HISTORIC AND DESIGN REVIEW COMMISSION

December 21, 2022

HDRC CASE NO: 2022-574
ADDRESS: 145 NAVARRO ST
LEGAL DESCRIPTION: NCB 986 LOT 11 THRU 13 AND E 5.14FT OF 10
ZONING: D, H, RIO-3
CITY COUNCIL DIST.: 1
APPLICANT: Peter Ketter/Sandvick Architects Inc.
OWNER: Kunal Mody/145 NAVARRO LLC
TYPE OF WORK: Construction of a rooftop addition, fenestration modifications, window replacement, rehabilitation, canopy installation and signage
APPLICATION RECEIVED: December 02, 2022
60-DAY REVIEW: Not applicable due to City Council Emergency Orders
CASE MANAGER: Edward Hall
REQUEST:

Proposed Exterior Alterations
HDRC Conceptual Review – December 2022

TITLE:
 Penthouse Elevations

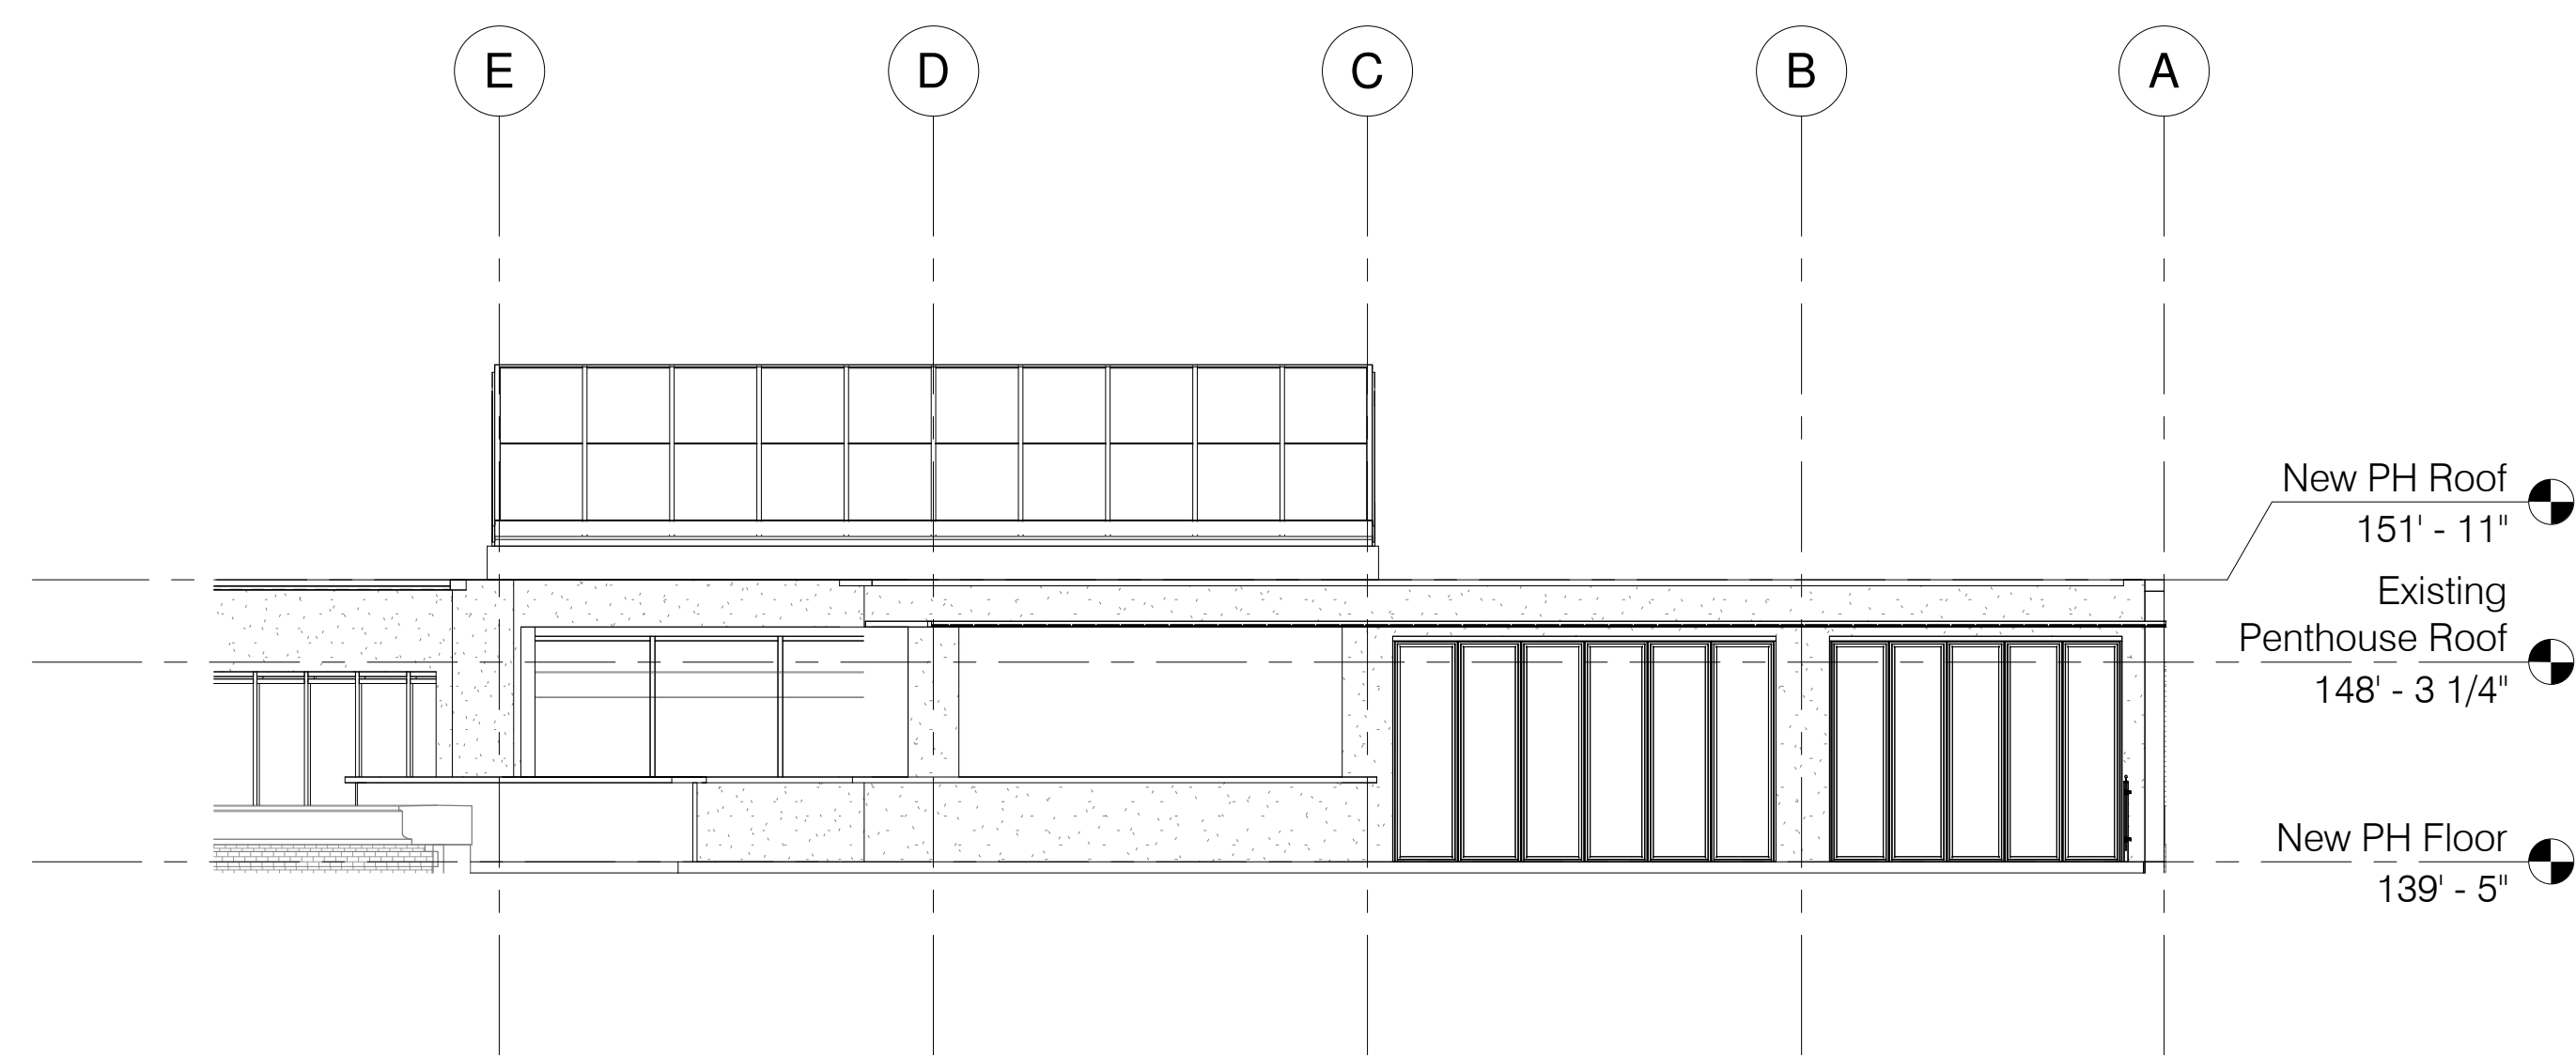
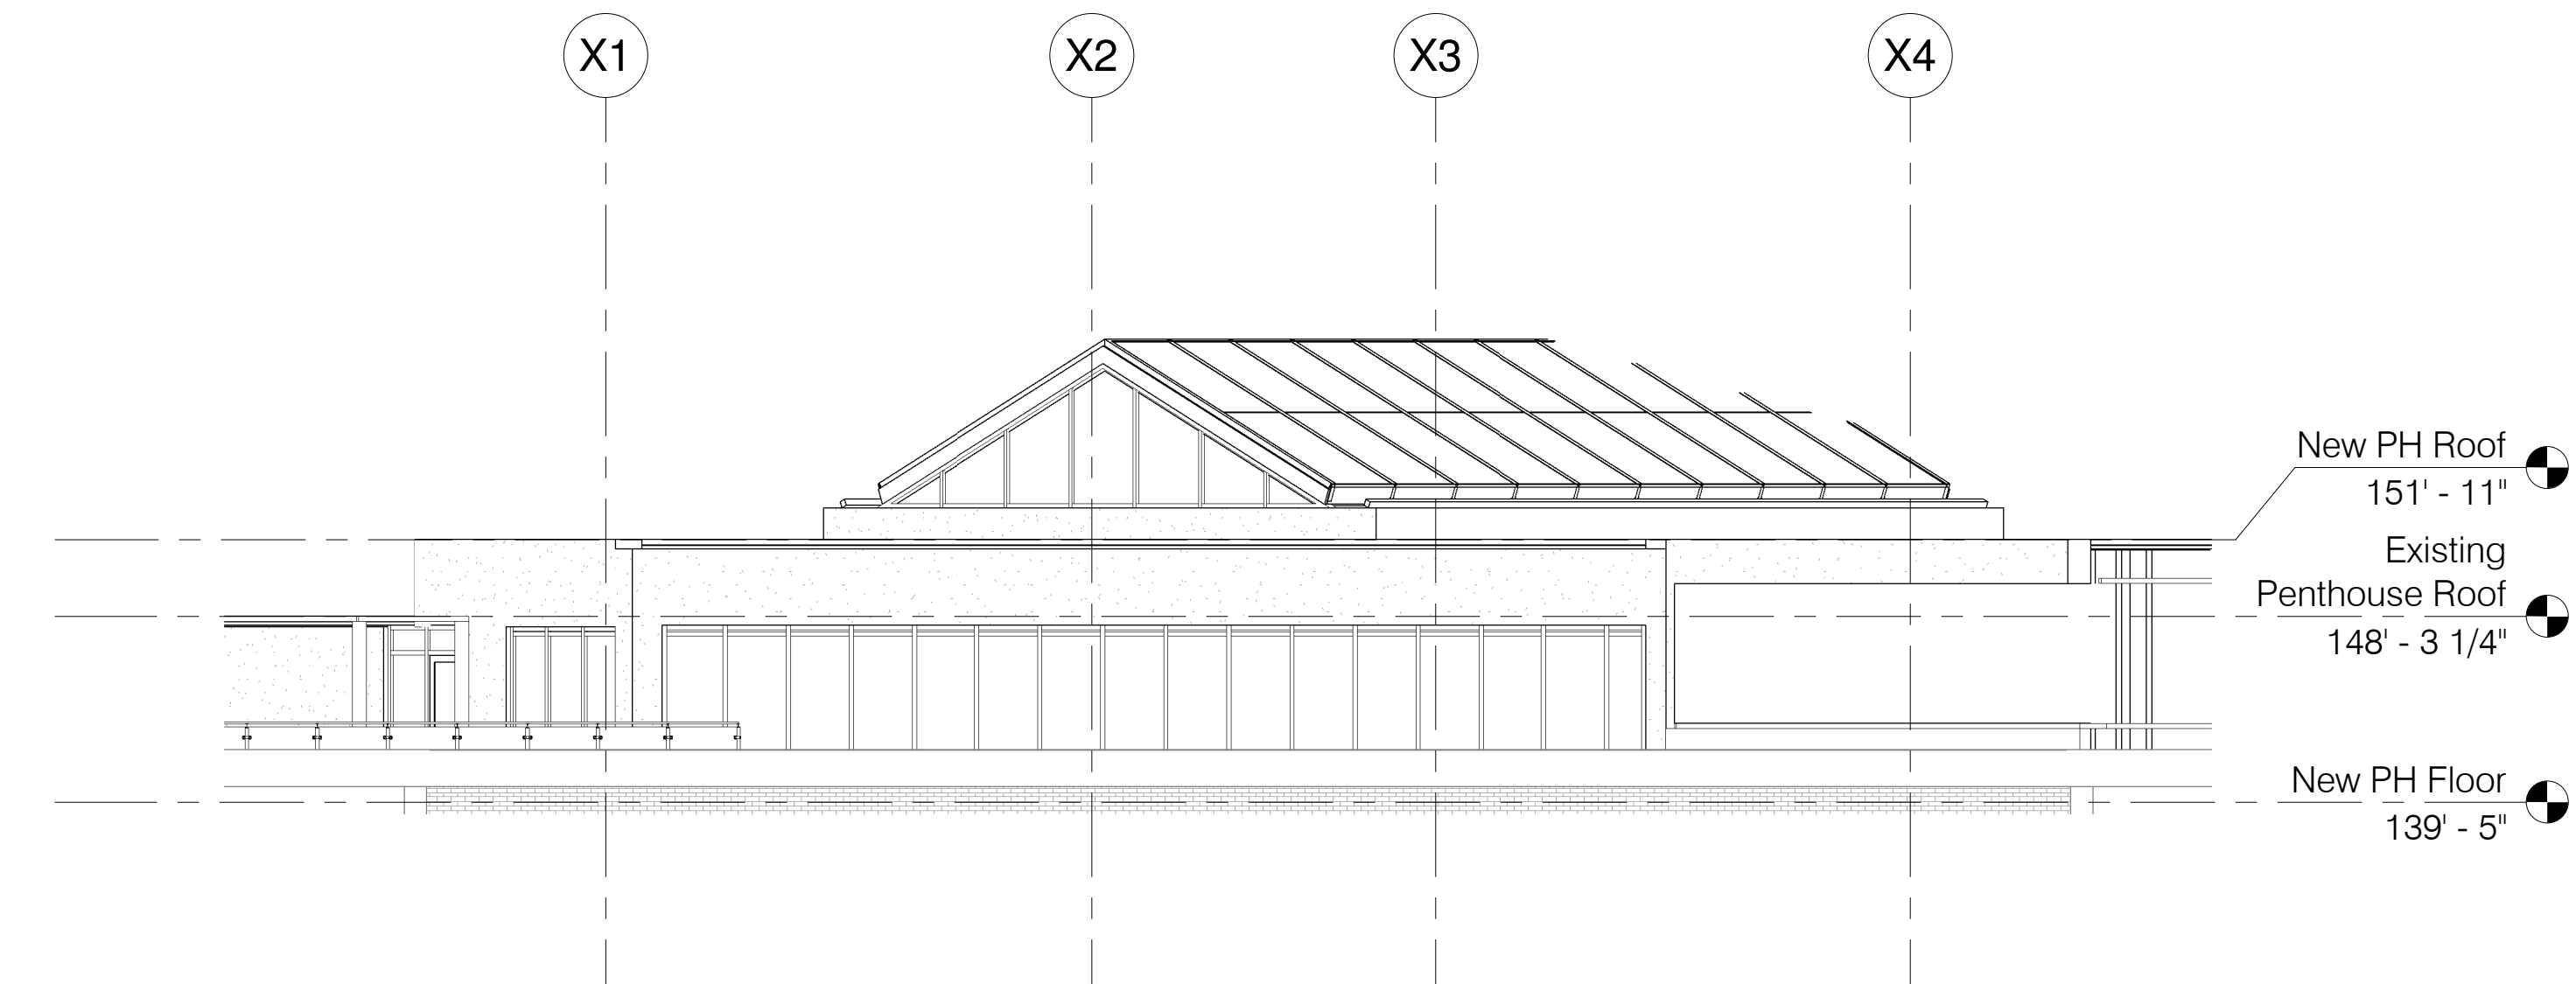
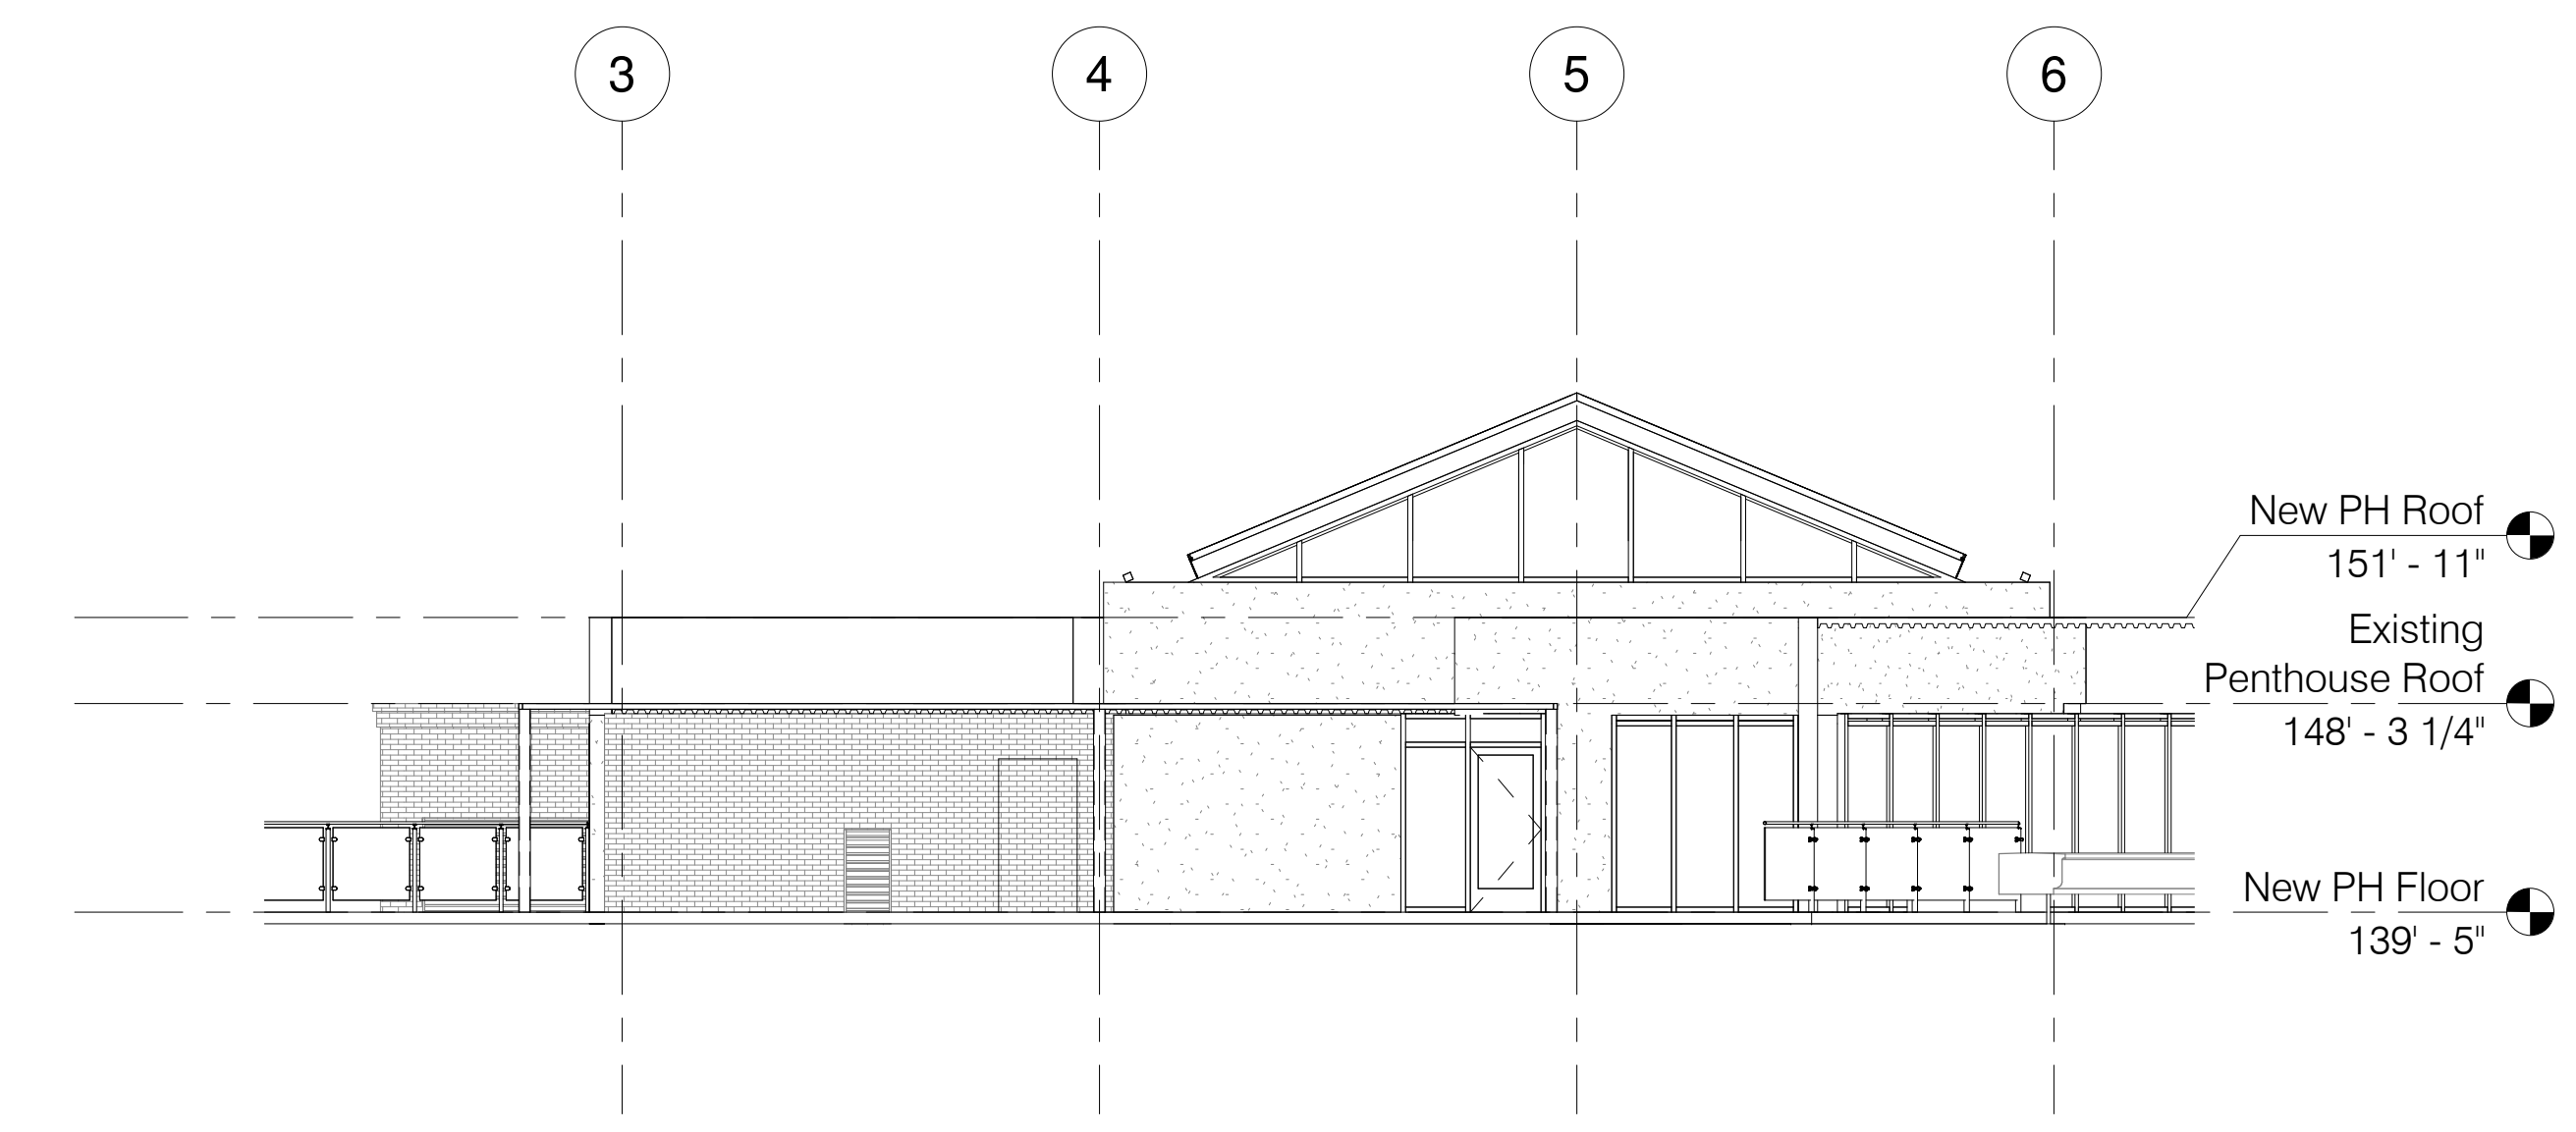
- j. **ADDITION** – The applicant has proposed to construct a rooftop addition to feature 1-story in height and approximately 3,700 square feet. The applicant has noted that the proposed addition will feature setbacks from the south, east, northeast and north facades.

- k. **ADDITION** – Per the Guidelines for Additions 2.A., new additions should be designed to be in keeping with the existing, historic context of the block and should be located to minimize visual impact from the public right of way. Additionally, the Guidelines for Additions 1.B.i. notes that the height of a rooftop addition should not be more than forty (40) percent of the original height of the structure. Staff finds that the proposed massing of the addition features massing that will be minimally visible from the right of way.

- l. **ADDITION (Materials)** – The applicant has proposed materials that include brick, stucco, metal coping and aluminum windows and storefront systems. Generally, staff finds the proposed materials to be appropriate and consistent with the Guidelines. Final material specifications should be provided for future review and approval. Additionally, staff finds that all windows should be consistent with staff's standards for windows in new construction and additions.

- m. **ADDITION (Architectural Details)** – The applicant has proposed architectural details that present a massing, materials and general design that is subordinate to the details and massing of the historic structure. Staff finds the proposed architectural details to be appropriate and consistent with the Guidelines.

8. Staff recommends approval of item #8, the construction of a rooftop addition, based on findings j through m, with the following stipulation:
 - i. That final materials specification be provided for future review and approval.

- ii. That the addition feature dark colored materials and paint colors.
9. Staff recommends approval of item #9, canopy signage, with the following stipulations. Staff recommends the following.
